# METROPOLITAN GOVERNMENT OF NASHVILLE AND DAVIDSON COUNTY

## STAFF RECOMMENDATION 2812 Belmont Boulevard January 20, 2021

**Application:** New Construction—Addition  
**District:** Belmont-Hillsboro Neighborhood Conservation Zoning Overlay  
**Council District:** 18  
**Base Zoning:** R8  
**Map and Parcel Number:** 11704029100  
**Applicant:** Blaine Bonadies, Architect  
**Project Lead:** Sean Alexander, sean.alexander@nashville.gov

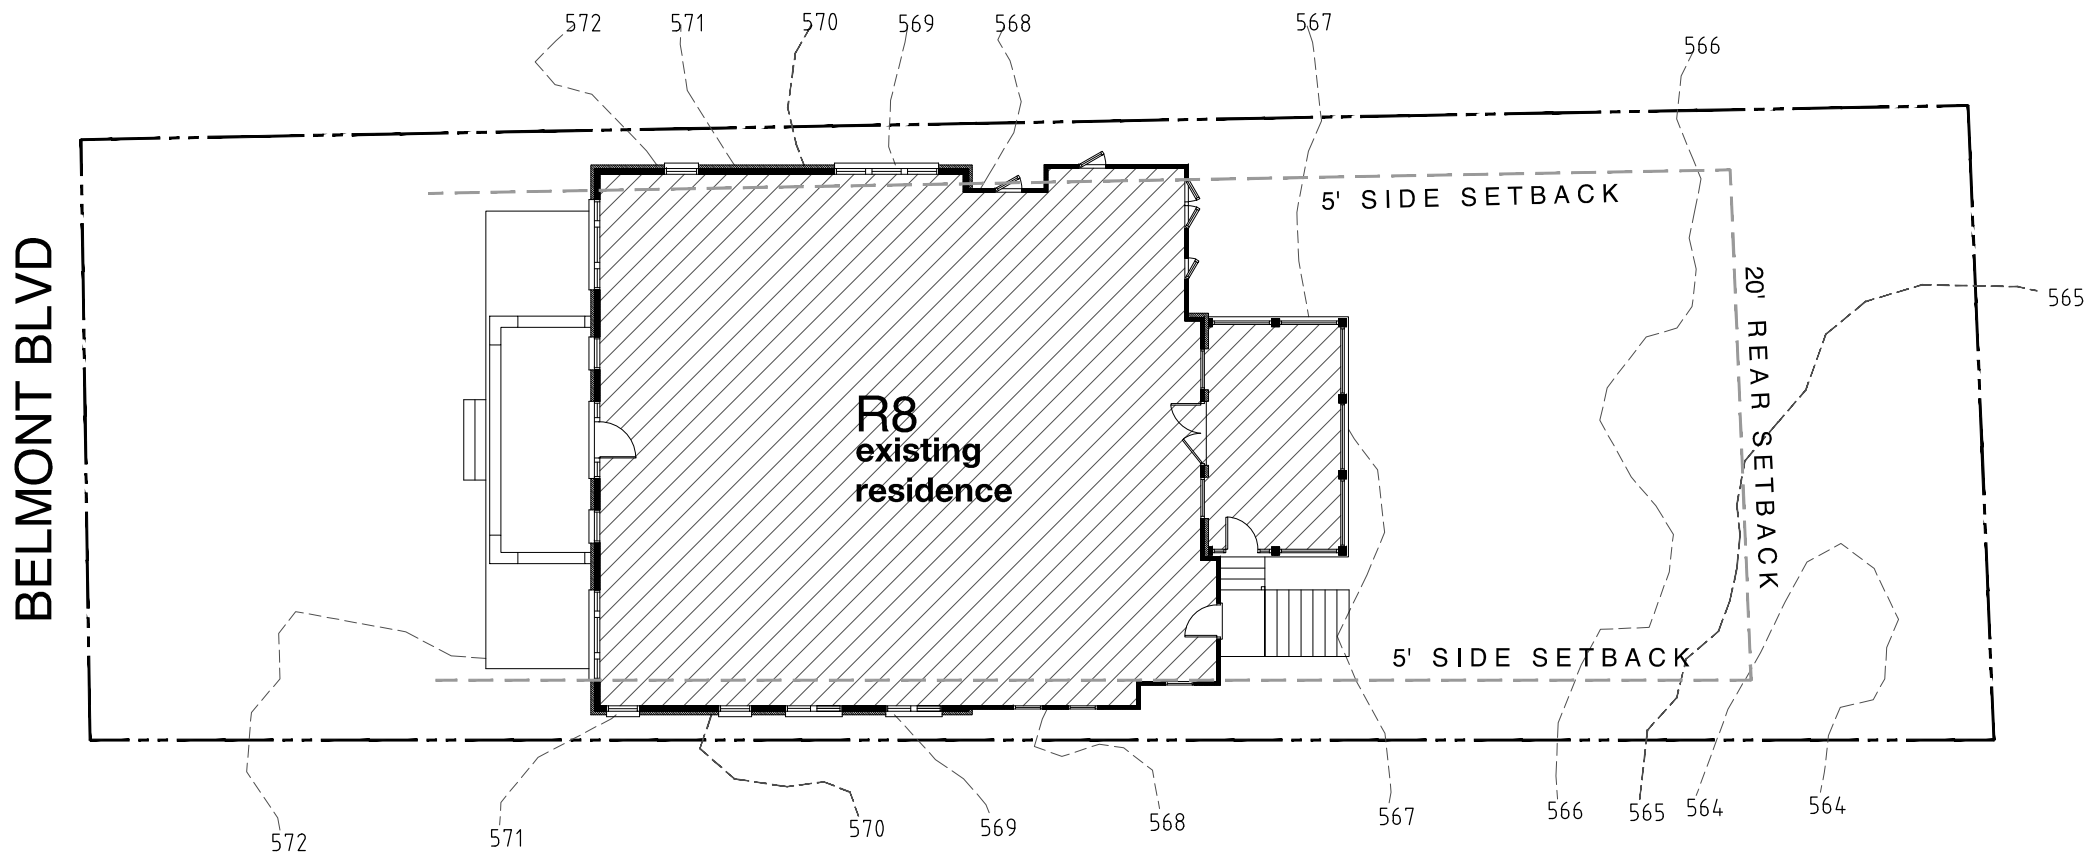
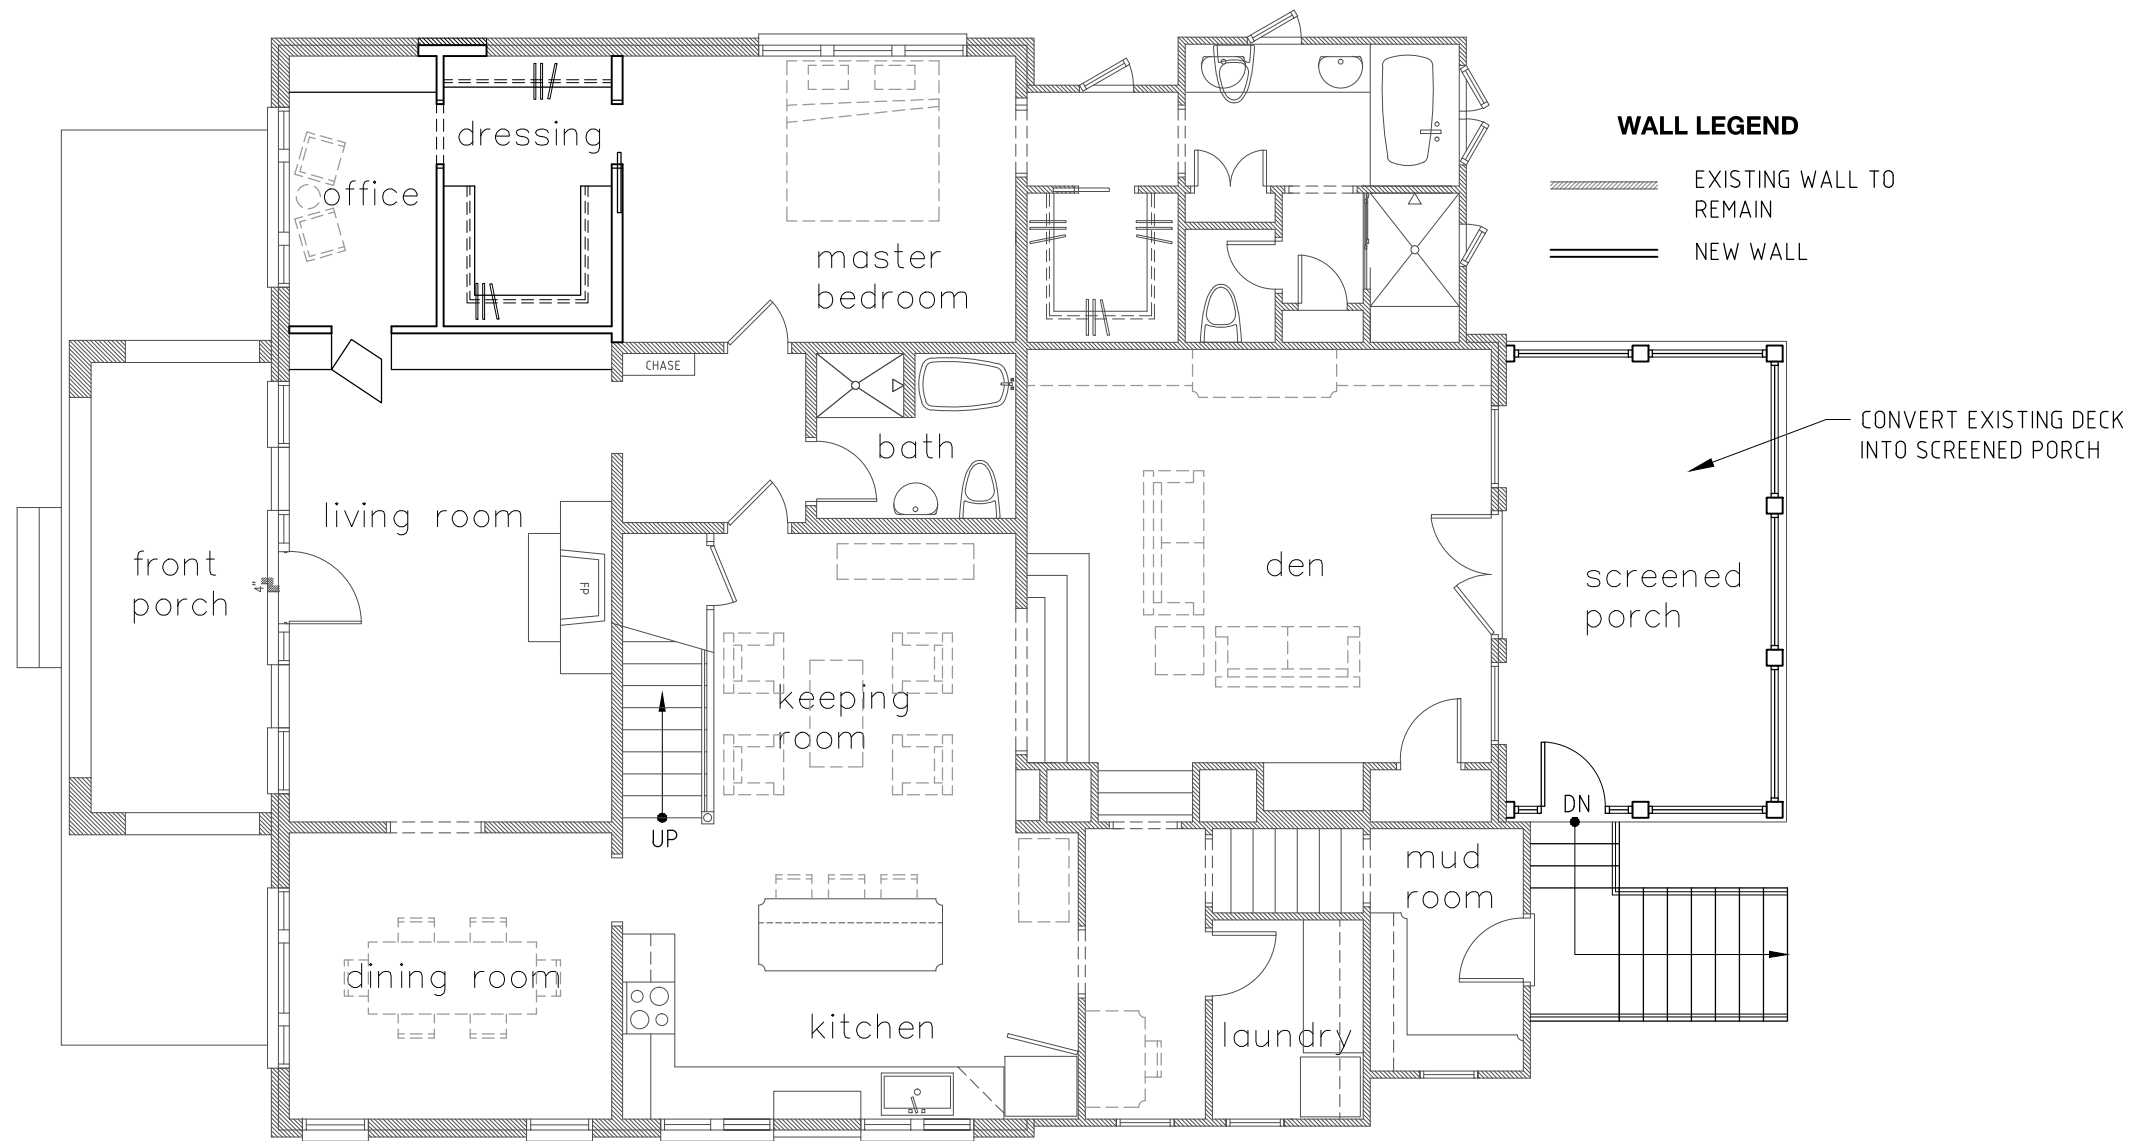
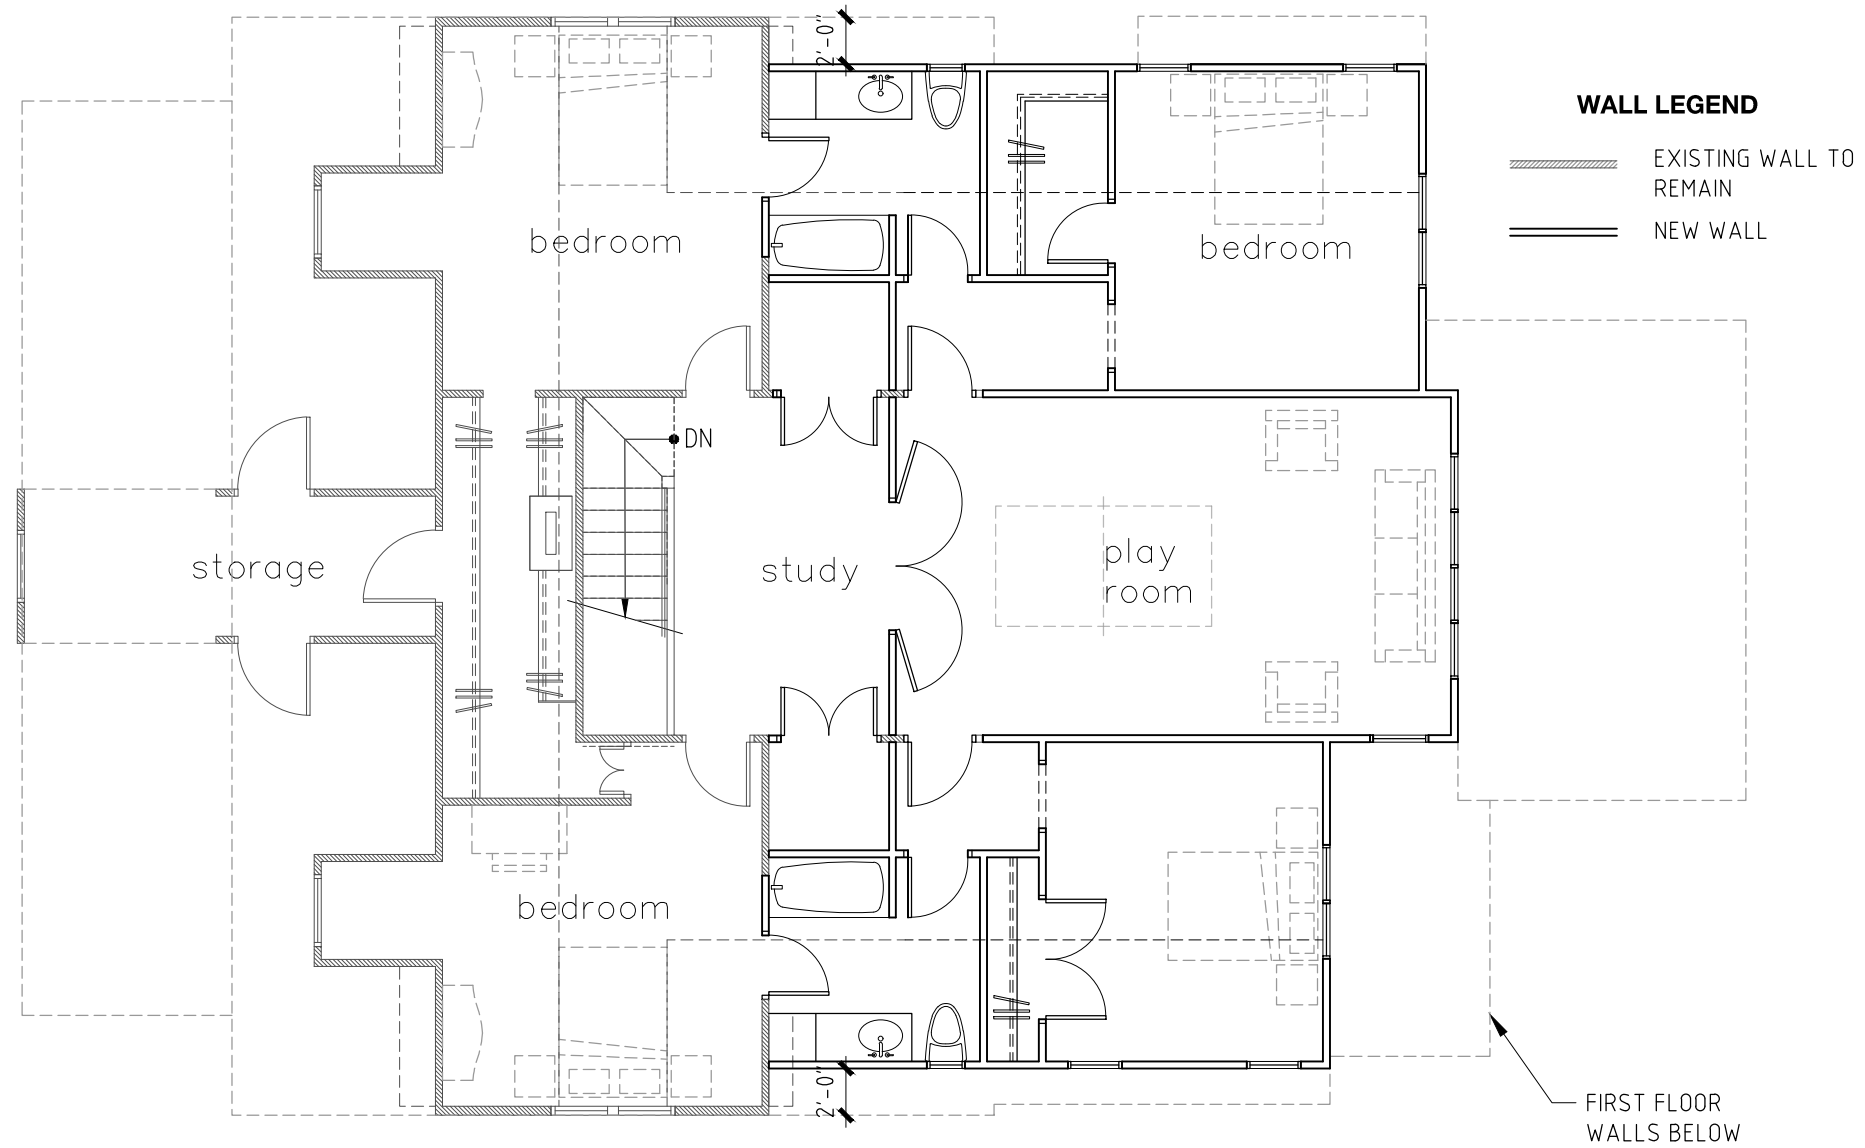
Proportion and Rhythm of Openings: The addition will have ample fenestration on both sides and the rear, with vertically oriented windows without any large expanses of walls between openings. This window pattern is compatible with the windows on the historic house.

Appurtenances & Utilities: The HVAC unit is currently on the right side of the house, behind the stoop that is to be removed. The HVAC is not indicated as being moved.

Staff finds the project’s proportion and rhythm of openings to meet Section II.B.1.g of the design guidelines.

**second floor plan**

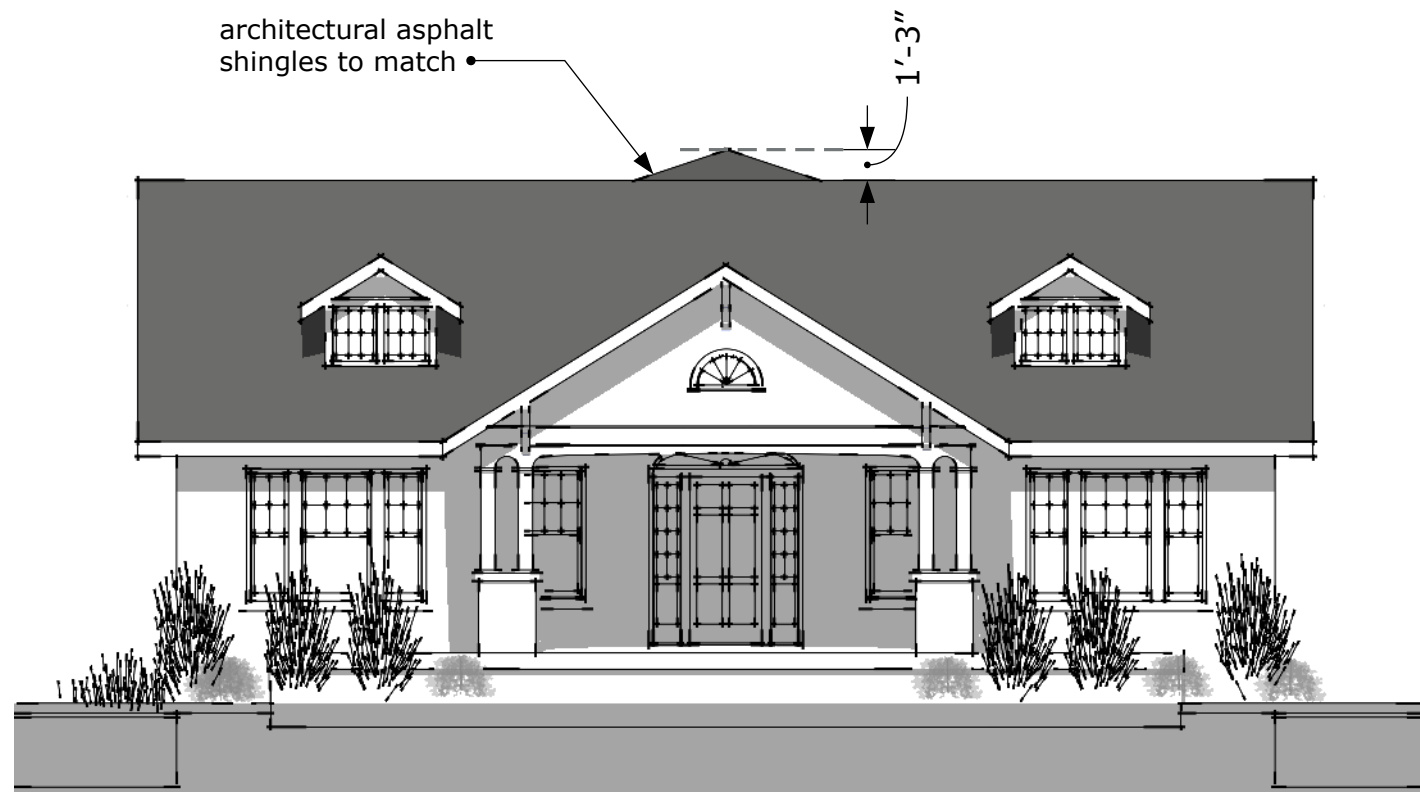
The upperstory addition will be stepped in two feet (2') on each side of the house, as is typical of upperstory additions. The first story addition will cover and enclose an existing rear deck, creating a screened porch. This component is stepped in twelve feet (12') on both sides.

The first-story, rear, porch addition is stepped in twelve feet (12') from both sides of the historic house and is twelve feet (12') deep.

**front elevation**

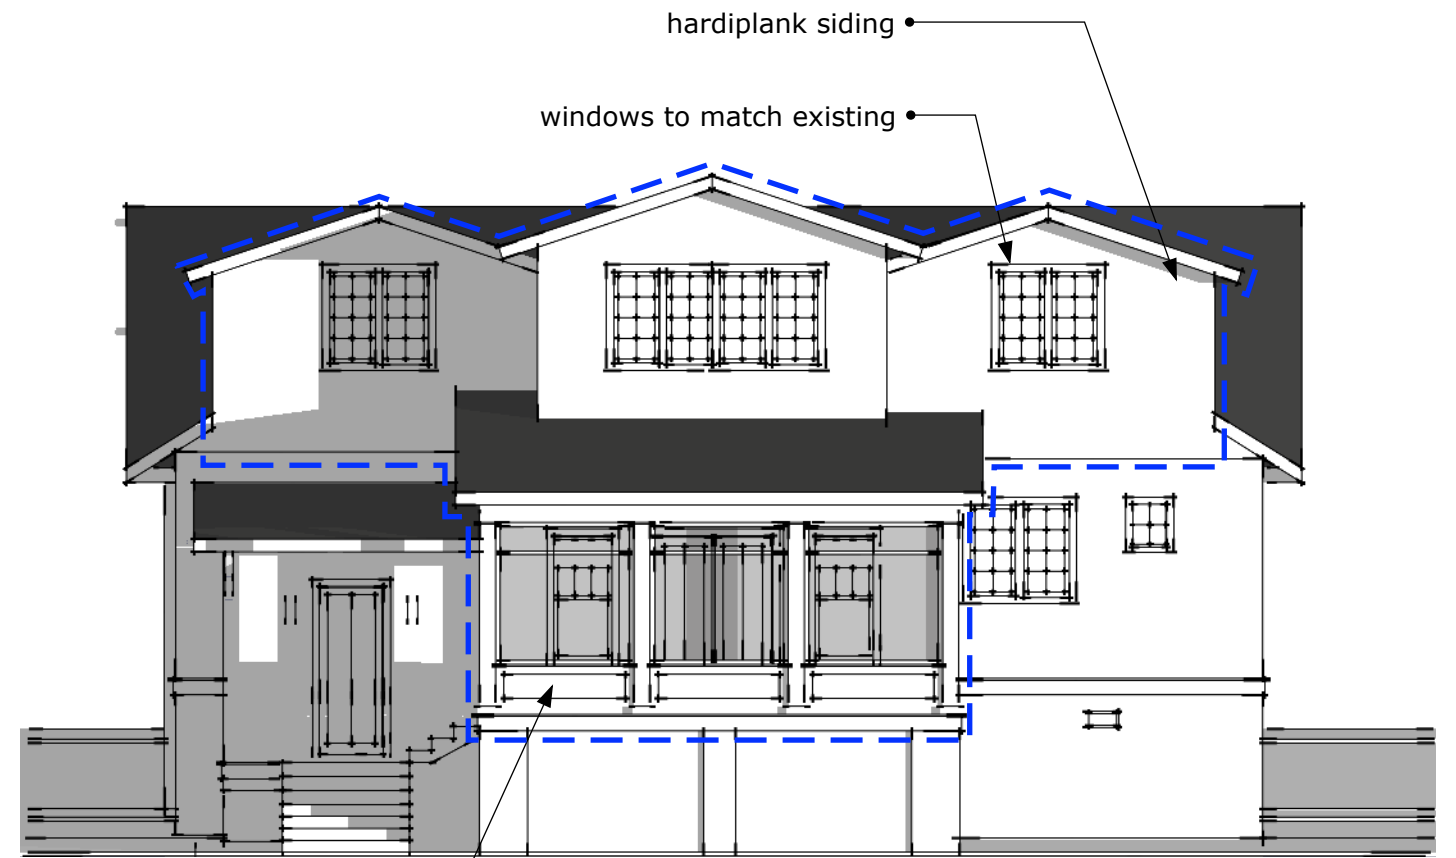
**Location & Removability:** The addition will include additions at the first story and upperstory. The upperstory component will attach at the existing ridge and extend up and back at a low pitch. This is similar to a ridge raise, but instead of the majority of the ridge increasing in height, is only an eight foot (8') wide section and the width will diminish as it extends up and back. This leaves the existing clay ridge caps intact, and the low pitch will obscure the additional height from the right-of-way.

Height & Scale: The width of the addition's upperstory will be four feet (4') narrower than the historic house, but the roof will be taller than that of the historic house. The taller roof ridge will be perpendicular to the existing roof ridge, with the height increasing gradually for a span of ten feet (10') before peaking at fifteen inches (15") above the original ridge height.

A two-foot (2') ridge raise would be possible with the existing roof form but the applicant proposes to push the additional height further back in order to preserve the existing form and historic clay ridge caps. In addition, the area of attachment of the addition's roof is much less than a ridge-raise which typically impacts all but the very edges of an historic roof. Staff finds the proposed addition to be consistent with additions that have been approved previously.

**rear elevation**

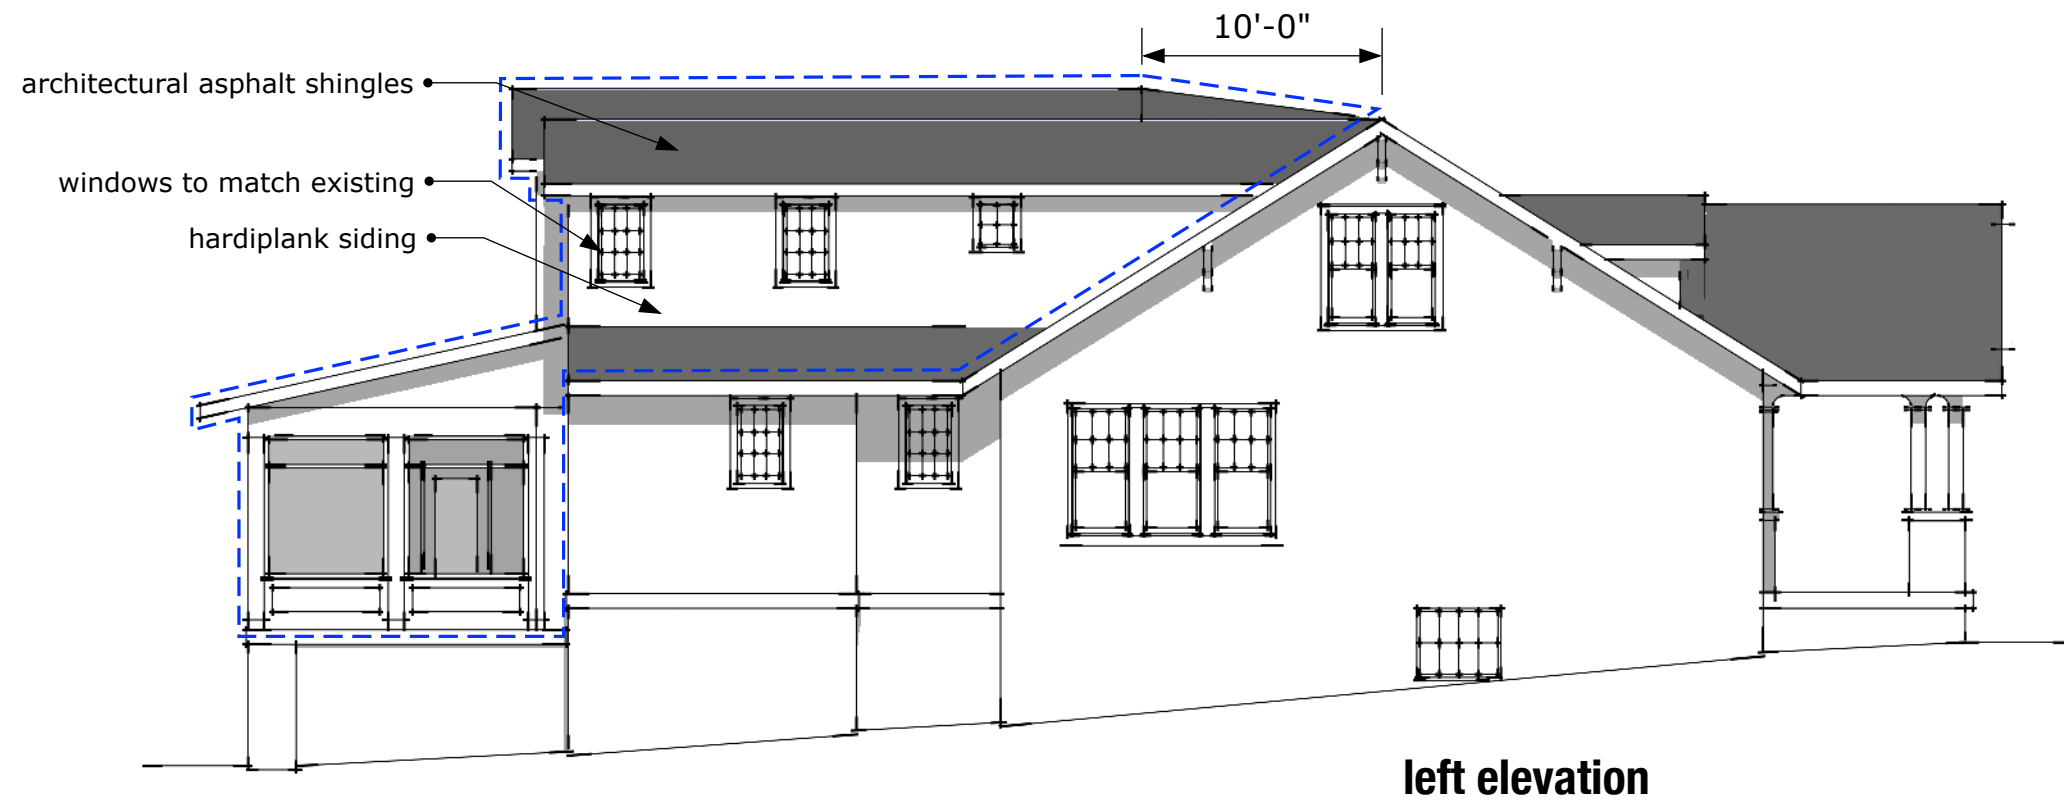
Roof form: The roof of the addition will consist of three rear-oriented gables, matching the pitch and form of the historic house’s roof. The rear porch addition will have a shed-roof with a pitch of 3/12.
